From: EKI Environment & Water, Inc. (EKI)

Subject: Comments on State Water Resources Control Board's Review of *Requests for Exclusion from Probationary Reporting and Fees, Tule Subbasin*

Figure 1. Coordinated Land Subsidence Minimum Thresholds in the Tule Subbasin, Kaweah Subbasin and Tulare Lake Subbasin. Annotated version of a figure presented at the 13 June 2025 Regional Subsidence Monitoring and Action Plan Meeting.

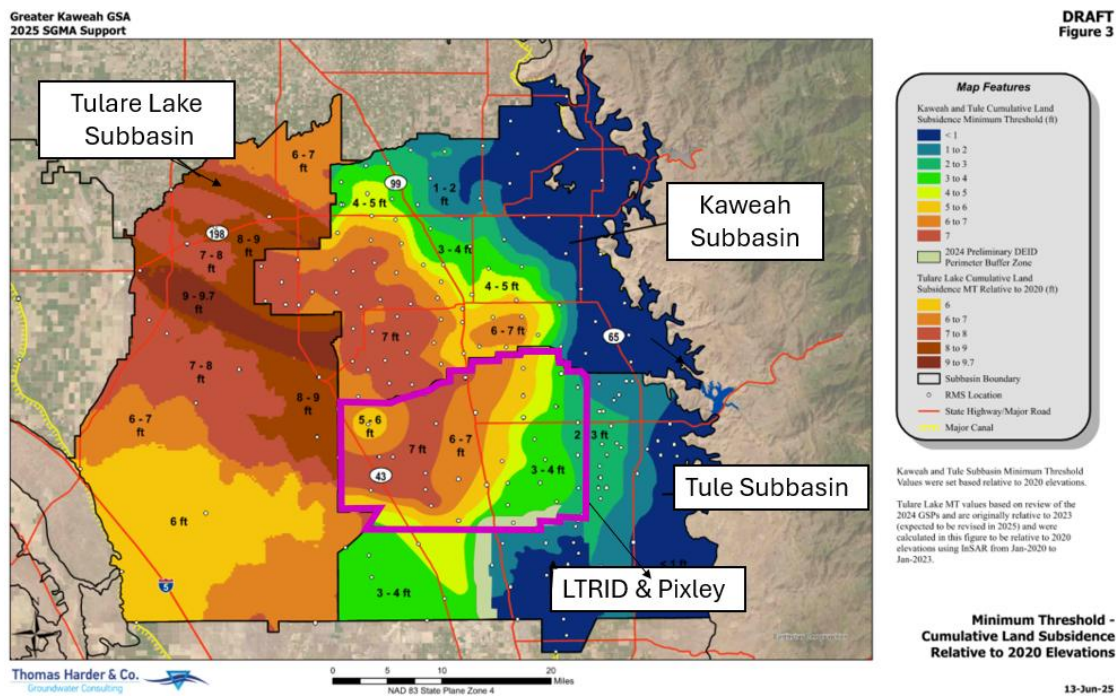
The Tule Subbasin GSAs also coordinated the subsidence MTs regionally to ensure consistency across subbasin boundaries as shown in **Figure 1**. TH&Co⁴ describes that, *“Land subsidence MTs were also selected to be coordinated with neighboring subbasins. Minimum thresholds along the northern, western*

and southern Tule Subbasin boundaries are consistent with those being proposed for the Kaweah Subbasin, Tulare Lake Subbasin, and Kern Subbasin, respectively.”

As described in the GSPs (Section 3.5.1.3.2), “The MTs for the land subsidence sustainability indicator were used to define the lower aquifer [groundwater level] MTs.” If the Staff Report recommends that the subsidence and water level MTs be revised significantly upward in the Tule Subbasin, then there will be a direct conflict with those that have, for example, been approved in the neighboring Kaweah Subbasin. It is not realistic to assume that the LTRID GSA could raise water levels by 100s of feet as the SWRCB is suggesting and eliminate any future subsidence, if directly at its border an approved GSP is allowing for 60 feet of additional water level decline and 7 feet of subsidence by 2040.

Figure 2. Illustrative Schematic of a Critical Head Value Aligned with the Adopted Subsidence MTs

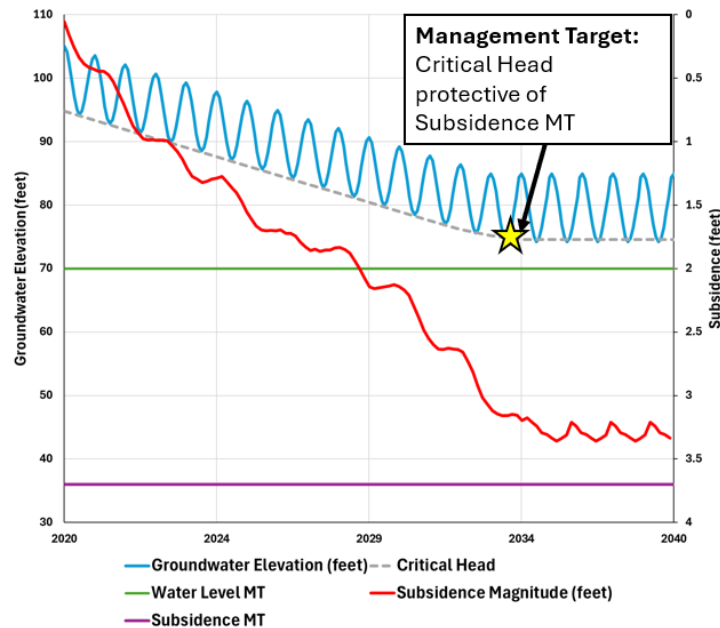
The BMP (page ES-1) states that GSAs should “adaptively manag[e] a basin as conditions change.” Presumably this would occur over the 2020–2040 planning horizon, with evaluation of conditions relative to sustainable management criteria, including MTs, measurable objectives (MOs), and allowable subsidence. The BMP framework recognizes that GSAs may not achieve immediate stabilization of subsidence; rather, groundwater levels should be managed over time to avoid significant and unreasonable impacts while progressing toward sustainability, as illustrated in Figure 2.

Consistent with this framework, the Tule Subbasin GSAs have established subsidence MTs that allow for a limited amount of additional subsidence during the SGMA implementation period, provided that such subsidence remains protective of critical infrastructure. The LT GSAs’ ongoing efforts, including development of Subsidence Management Plans (SMP), are focused on adaptive management and achieving the MO of no inelastic subsidence after 2040, consistent with the SGMA timeline.

Figure 3. Illustrative Schematic Depicting how the Critical Head Referenced in the Staff Report is not Consistent with the Adopted Subsidence MTs

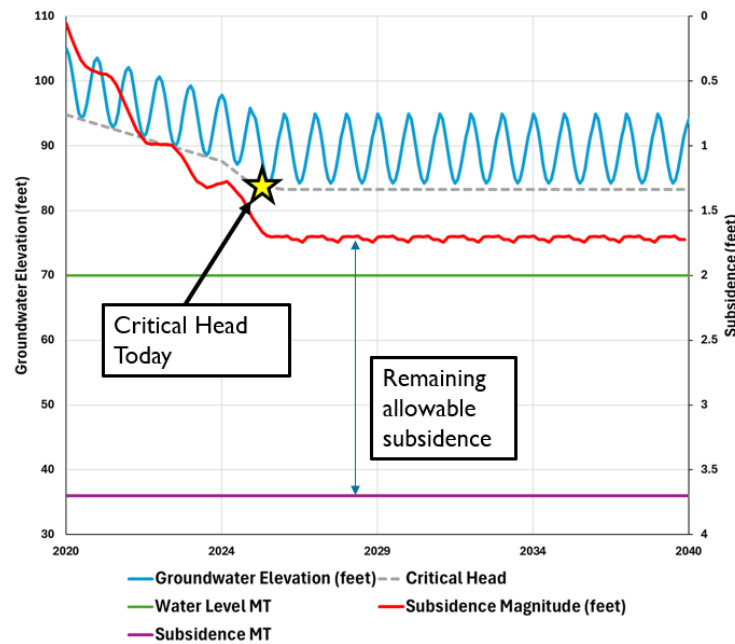
The Staff Report relies on a study conducted by Intera⁵ that includes an interpretation of critical head (CH) conditions as of 2024 and applies these values as a benchmark for evaluating groundwater and subsidence management in the Tule Subbasin. As shown in **Figure 3**, the CHs referenced in the Staff Report are based on 2024 conditions, which effectively precludes any additional inelastic subsidence going forward, in contrast to the adopted subsidence MTs, and would substantially limit the LT GSAs’ operational flexibility to achieve sustainability by 2040. This framing assumes that subsidence must be halted at the present-day instead of over the SGMA implementation timeline, which allows for a transition period through 2040 as long as significant and unreasonable impacts are not occurring. As stated above, per work done by TH&Co⁴, the adopted subsidence MTs in the LT GSAs are designed to prevent significant and unreasonable impacts.

Figure 4. Comparison of Observed Groundwater Levels and Critical Head (2024) Estimates at the LT GSA Sites (Intera, 2025) to Other BMP Example Sites

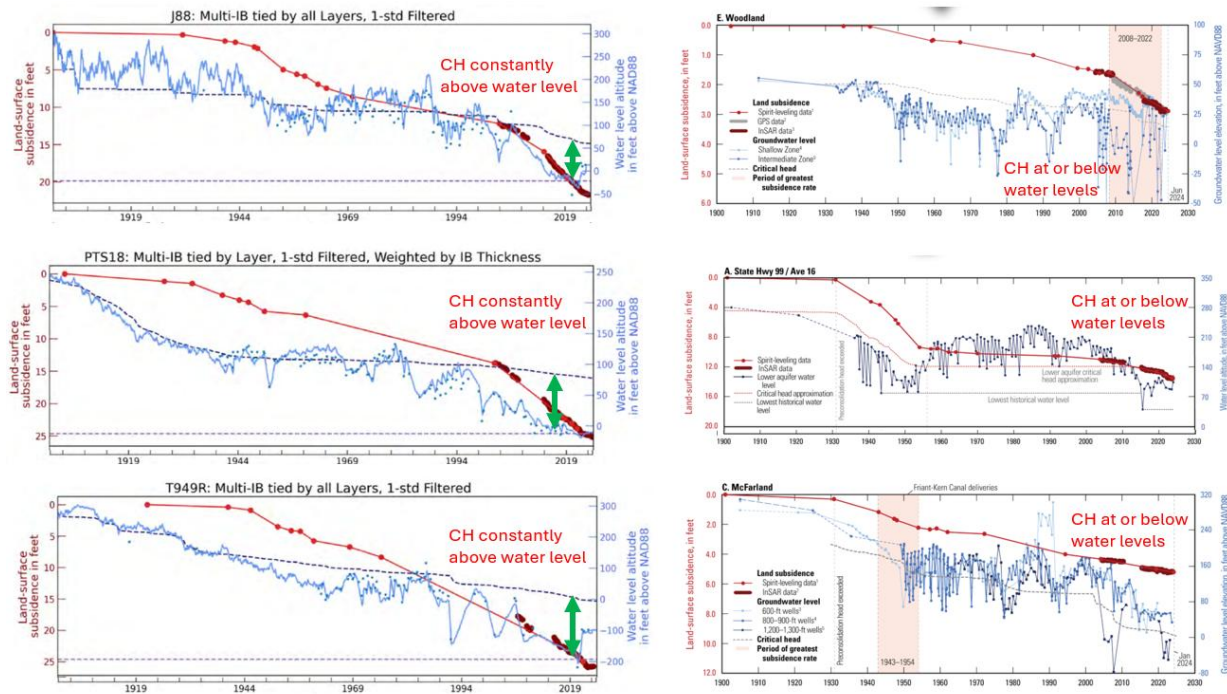
The resulting CHs estimated from the 1D models for the three sites within LT GSAs depart substantially from observed groundwater levels over the past three decades, remaining consistently above measured water levels (see the left column on **Figure 4**). This behavior contrasts with other example sites in the BMP where the estimated CH and groundwater levels generally remain more closely aligned (see the right column on **Figure 4**). The divergence between the observed water levels and the CH values cited in the Staff Report at T949R, PTS18 and J88 may stem from model parameterization, post-processing, or expert judgement, however, the LT GSAs and other interested parties lack visibility and input into the CH estimates cited by the Staff Report at these locations.

Figure 5. Preliminary Critical Head Estimate for J88 and T949R

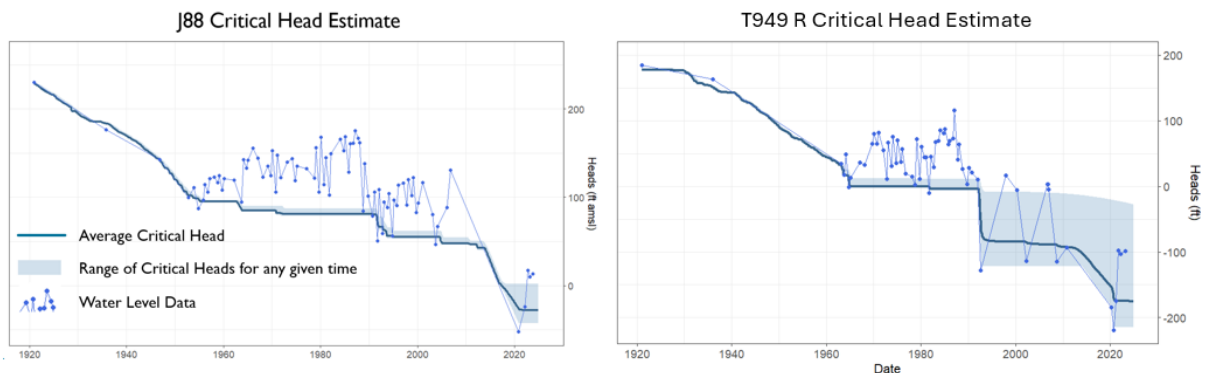
The BMP (page C-9) states that “For models that use multiple systems of delay interbeds, an average can be taken across each system of delay interbeds to provide a representative critical head”. This recommendation explicitly supports the use of representative (e.g., average or central tendency) values rather than extreme values (e.g., maximum or upper bounds) when interpreting modeling results that inherently produce a large range of plausible outcomes.

To date, the LT GSAs have applied the BMP-recommended 1D modeling approach to evaluate CH at the existing sites cited by the SWRCB (J88, T949R, and PTS18)⁸ and are working to expand this analysis to its actual groundwater level and land subsidence RMS, where sufficient data are available. As an example, **Figure 5** presents preliminary CH estimates for T949R and J88, and **Table 1** summarizes key statistics of these estimates, including the modeled range of values.

Figure 6. Comparison of Groundwater Level MTs and 2024 Simulated Critical Heads

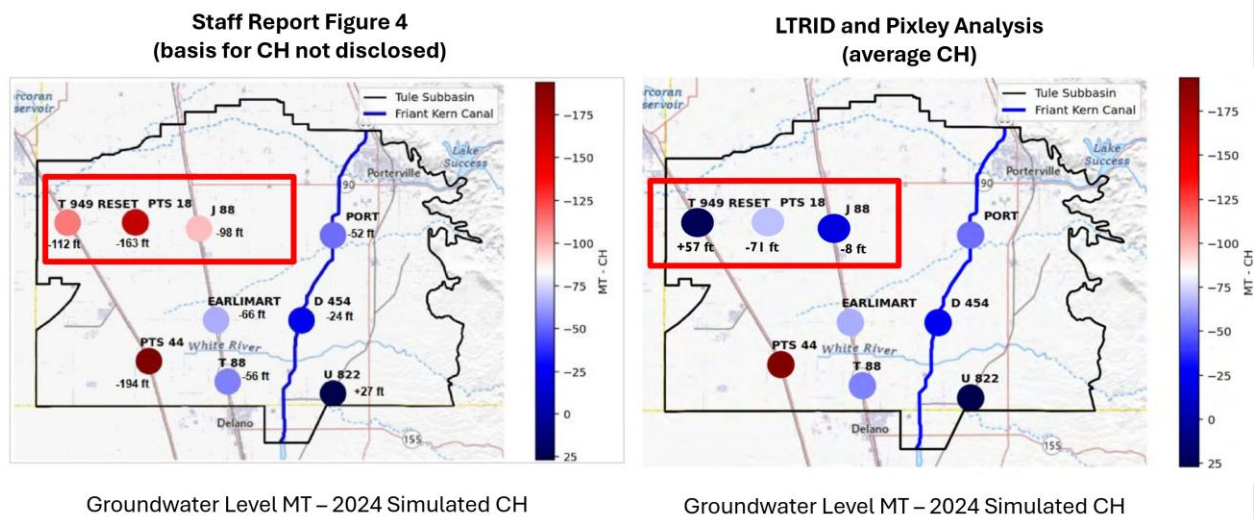
These results (and those shown on the right side of **Figures 6 and 7**) demonstrate that, when evaluated using representative average CH values consistent with BMP guidance, the groundwater level minimum thresholds (GWL-MTs) and current water levels within the LT GSA areas are generally much closer, and in some cases above, the CH values presented in the Staff Report. And again, these CH values do not reflect the additional allowable subsidence that was determined in the GSPs to not cause significant and unreasonable impacts to critical infrastructure⁴.

Figure 4 of the Staff Report compares interpolated lower aquifer GWL-MTs to the estimated CH values and states that the LT GSAs would need to increase GWL-MTs by approximately 100 to 163 feet (left side of **Figure 6**). Figure 5 of the Staff Report further shows that current groundwater levels are approximately 50 to 100 feet below the estimated CH at these sites (left side of **Figure 7**). Having conducted this independent analysis, it is not clear to us what the basis was for the CH estimates used in the Staff Report, as they appear to be closer to the maximum potential CH value generated by the 1D model, and significantly above the BMP-recommended average values.

Figure 8. Simulated Projected Subsidence under Various Projected Water Level Scenarios

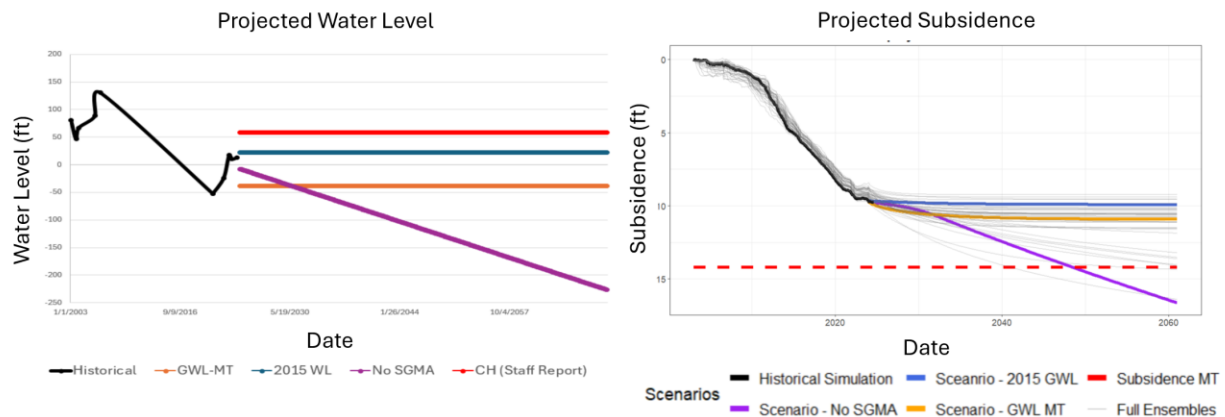
As shown in **Figure 8**, BMP 1D model simulations were performed at the LT GSA sites under multiple groundwater level scenarios, including: (1) 2015 groundwater level conditions; (2) GWL-MT conditions; and (3) a no-SGMA implementation scenario. These simulations were evaluated across full ensemble realizations to account for model uncertainty and variability in aquifer response. Results indicate that, under GWL-MT conditions, projected subsidence remains below the established subsidence MT through 2040 across the ensemble range. Furthermore, model results indicate that post-2040 subsidence behavior generally stabilizes under GWL-MT conditions, with most ensemble realizations showing minimal additional subsidence over time. This behavior is consistent with the intended SGMA implementation period (2020–2040), during which some level of subsidence may occur, followed by stabilization as groundwater conditions are managed sustainably.

Overall, these results provide quantitative support that the LT GSAs’ GWL-MTs appear to be sufficient to maintain subsidence within acceptable limits and achieve long-term sustainability objectives and do not need to be radically re-defined as suggested in the Staff Report. Rather, the focus should remain on managing water levels above the GWL-MTs.
